WO 14-0032

Subject: Docket No. 50-482: Supplemental Information for Response to Request for Additional Information Regarding License Amendment Request for the Transition to Westinghouse Core Design and Safety Analysis

### **2. ESGB-RAI-1**

Figure 4-1 Containment Sump pH versus Time

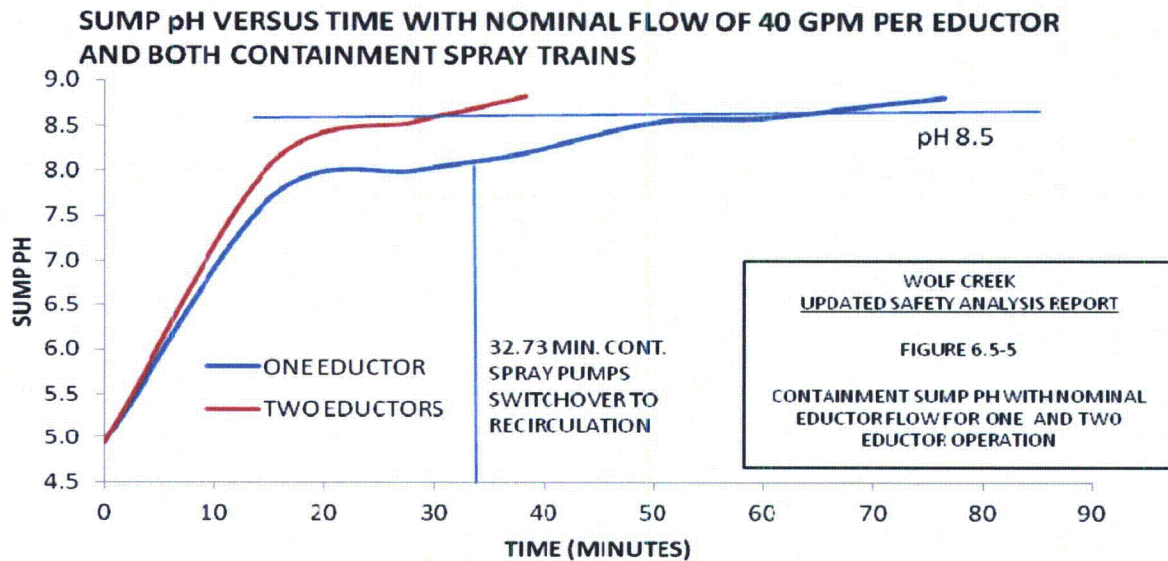
*Describe the analysis methodology used to determine the pH in the sump water during the period of 30 days post-LOCA. Include detailed calculations of time dependent pH values in the sump during a 30 day period post-LOCA to demonstrate that the pH remains basic throughout this time period.*

The Westinghouse calculation determined a long-term sump pH of 8.7, while the CLB calculation determined a minimum value of 8.6. The slightly higher pH in the Westinghouse calculation is attributed to the use of a different boron/NaOH/pH correlation. In either case, the results show that the sump pH remains above the CLB value of 8.5 and well above the NRC-required value of 7.0 after the minimum amount of NaOH is injected into the sump.

In the CLB calculation, the limiting system alignment of both containment spray trains operating with one NaOH eductor in service results in a sump pH of 7 in approximately 15 minutes, with the final long-term pH of 8.6 in approximately 80 minutes. The less limiting case of both Containment Spray trains operating with both NaOH supplies in service results in a sump pH of 7 in approximately 11 minutes, with the final long-term pH of 8.6 in approximately 45 minutes. For the Westinghouse calculation, the limiting system alignment of both containment spray trains operating with one NaOH eductor in service results in a sump pH of 7 in approximately 11 minutes, with the final long-term pH of 8.7 in approximately 70 minutes. The less limiting case of both containment spray trains operating with both NaOH supplies in service results in a sump pH of 7 in approximately 9 minutes, with the final long-term pH of 8.7 in approximately 35 minutes.

Figure 4-1 shows that the acceptance criteria of sump pH > 8.5 (minimum) is met for one or two containment spray eductors in service, considering also the generation of strong acids inside containment post-LOCA, consistent with the guidance of NUREG/CR-5950.
